Santa Rosa U.S. Highway 101 Bicycle and Pedestrian Overcrossing

Initial Study with Mitigated Negative Declaration

The IS/MND was circulated to the public for 30 days between June 22, 2020 and July 24, 2020. Comments received during this period are included in Appendix G. Elsewhere throughout this document, a vertical line in the margin indicates a change made since the draft document circulation. Minor editorial changes and clarifications have not been so indicated. To obtain a copy of this document and the related technical studies please call or write:

FIGURE 2.4-1

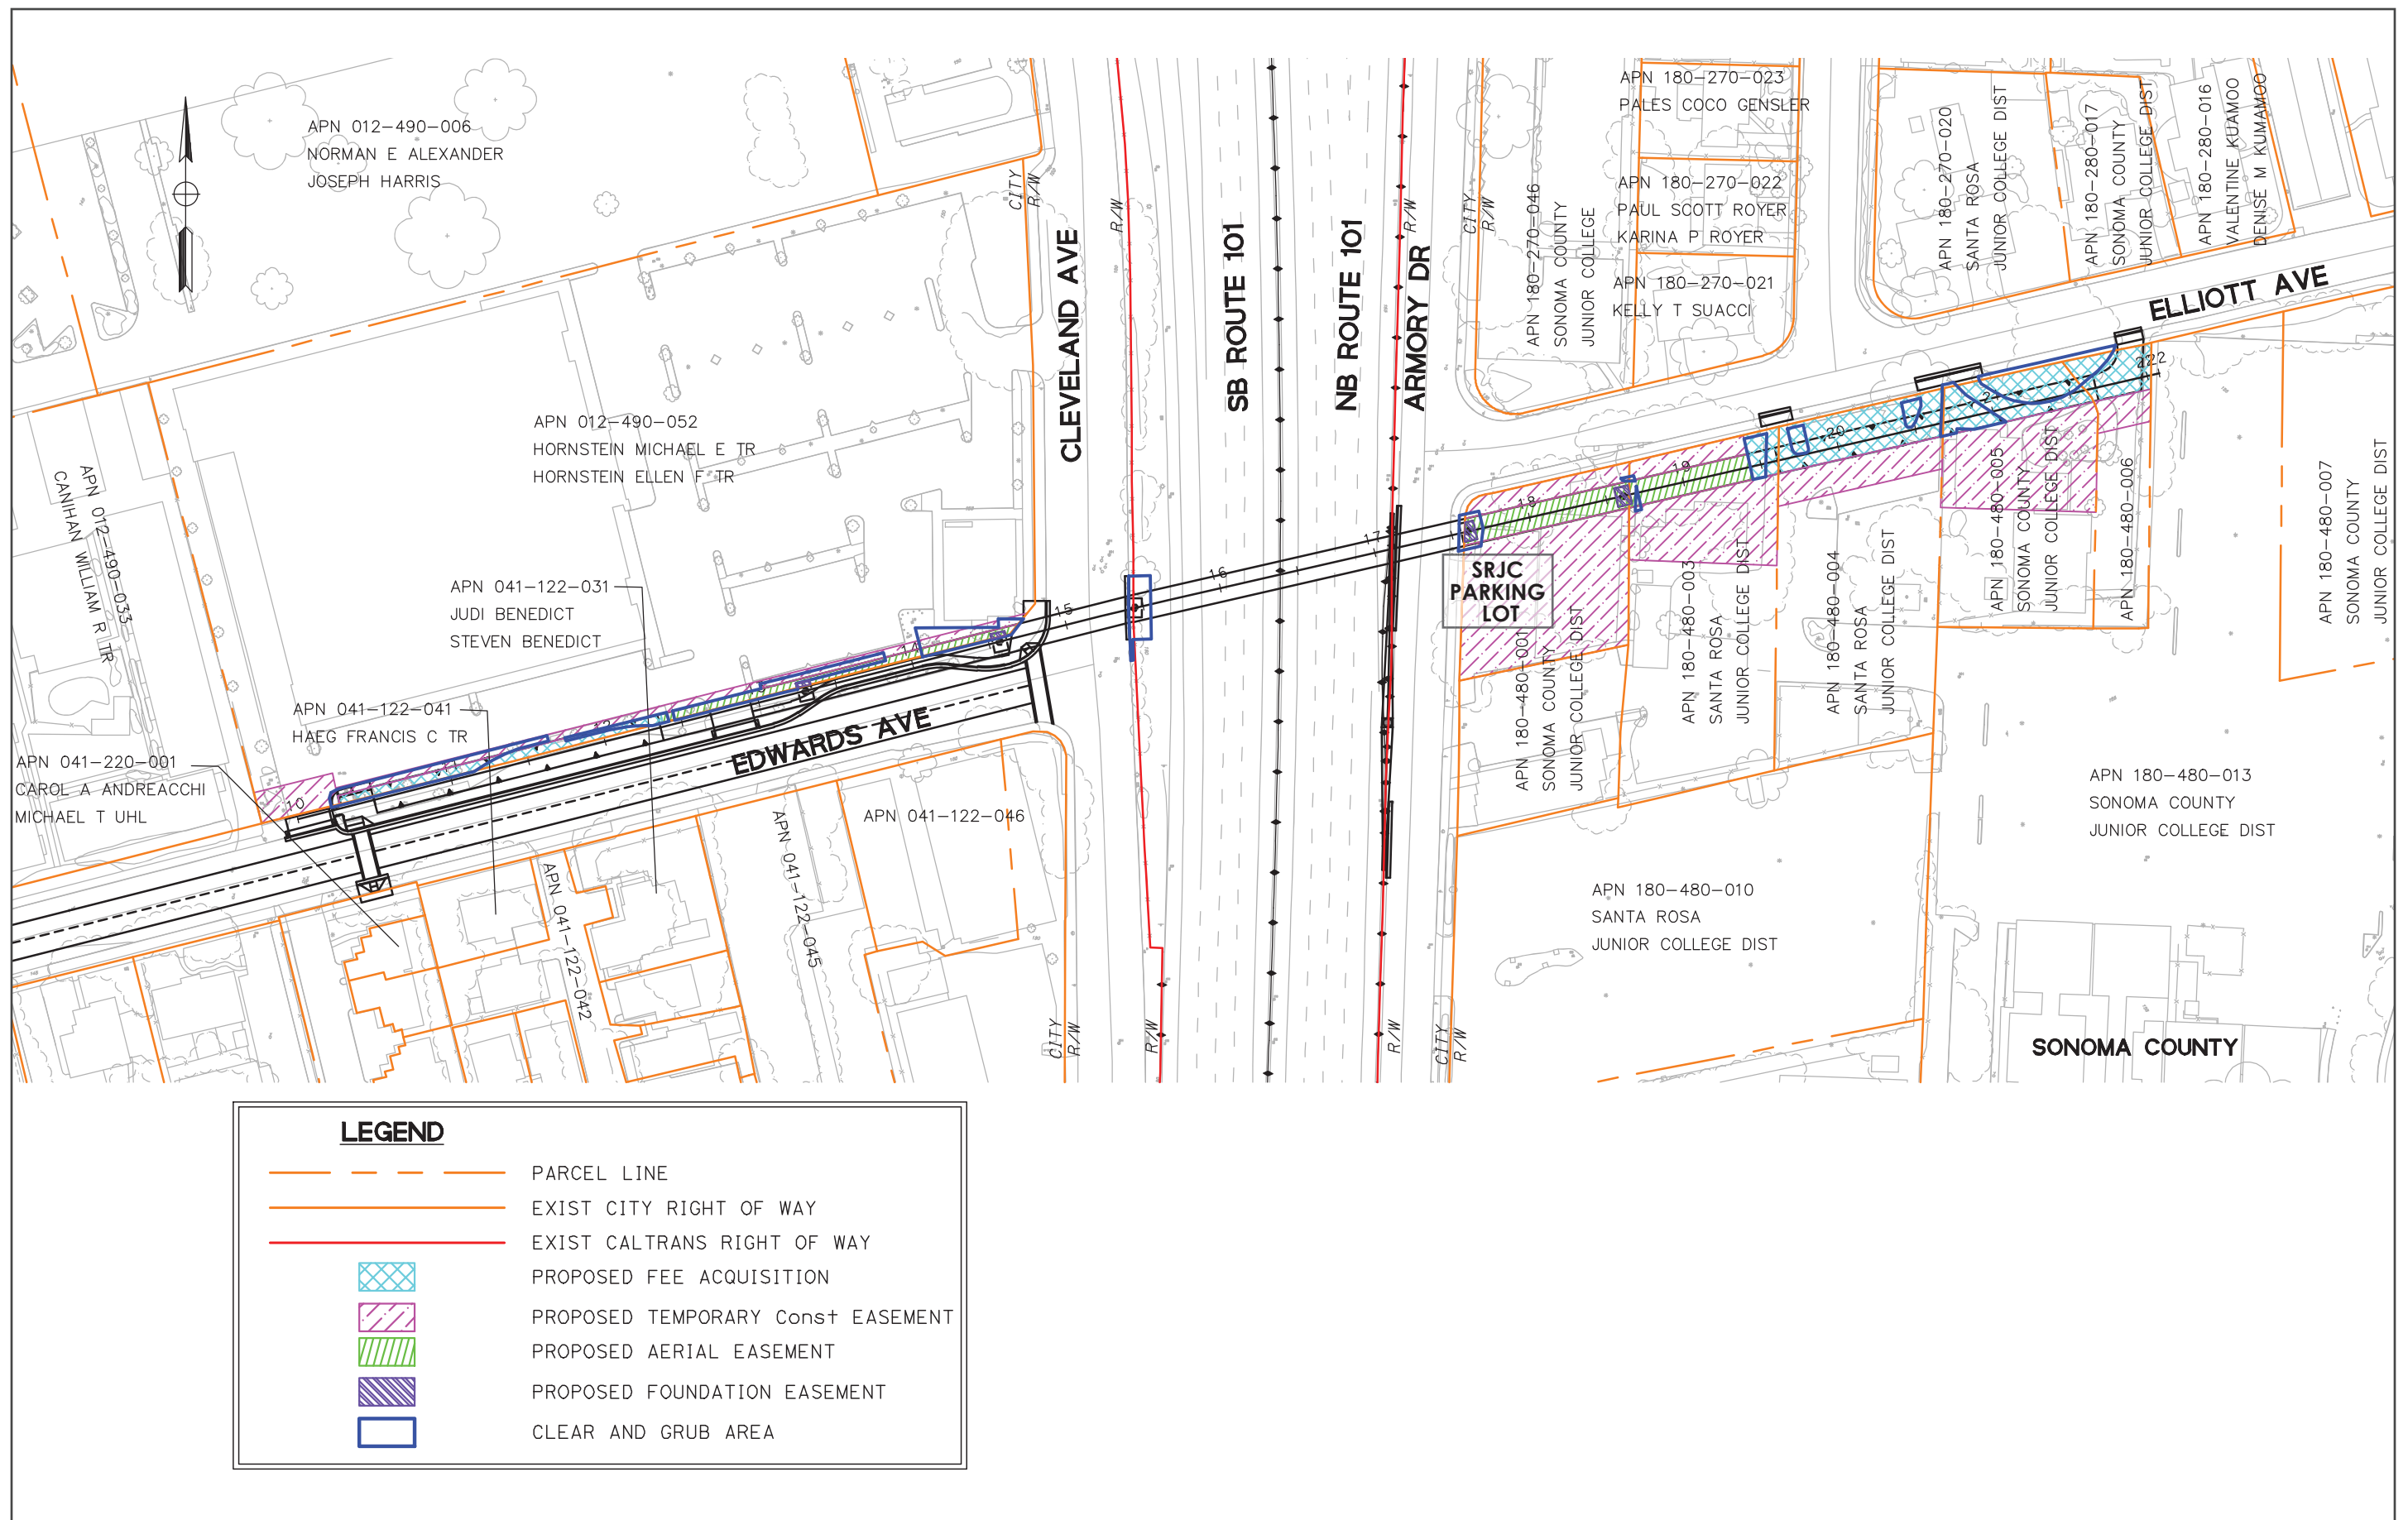
- Finally, Figure 2.4.1 depicts a temporary construction easement completely blocking access to the service/loading area of Dick's, which would result in the delivery trucks trying to maneuver into different areas of the Trust parcel

Caltrans acknowledges the commenter's concern that the temporary construction easement would block access to the service/loading area of Dick's Sporting Goods. Refer to response to **Common Comments "CST-1, Construction duration."** Construction of the Project would be phased over approximately two years and would not result in closure of the Edwards Avenue access to the parking lot for the entire construction period. The temporary construction easement shown blocking access to the service/loading area is required for construction of the sidewalk and driveway near the west touchdown of the bridge. It is anticipated that the area of the temporary construction easement blocking the driveway would be required for no more than approximately two weeks in duration. During the reconstruction of the driveway and sidewalk, any disruption in access will be coordinated with the property owner in order to provide access for service/loading throughout the duration of the temporary construction easement. Delivery trucks would continue to have access to the property via Cleveland Avenue. Project construction would not result in any additional safety hazards at the Trust parcel and pedestrian and bicyclists would continue to have access to the primary Coddington Mall entrance on Edwards Avenue as described above in Response to Comment 2.

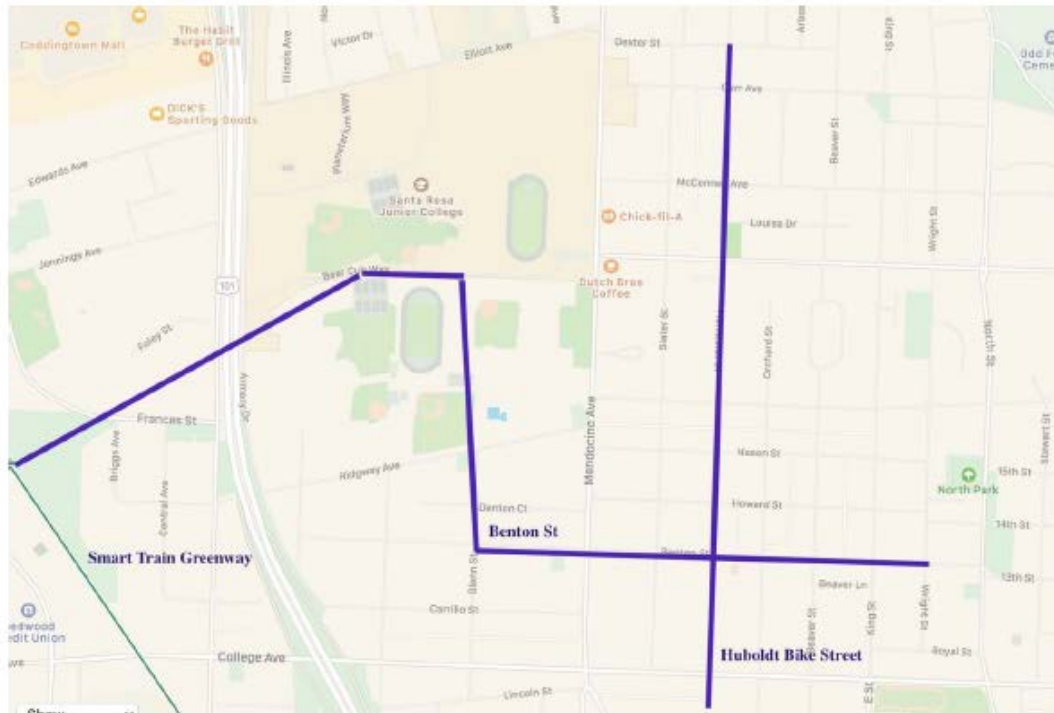
- 1 I think building at Elliot would force a connection to the Humboldt Bike Street over Mendocino to Dexter. That intersection would need to be a "jog" in which the cyclist would turn onto Mendocino in the center divide for a short distance. That is not ideal, and unsafe on such a busy main road.

As an experienced road cyclist, I believe that crossing Mendocino to safely reach Humboldt Bike Road is best at Benton St, south of Santa Rosa High School. I have attached a drawing.
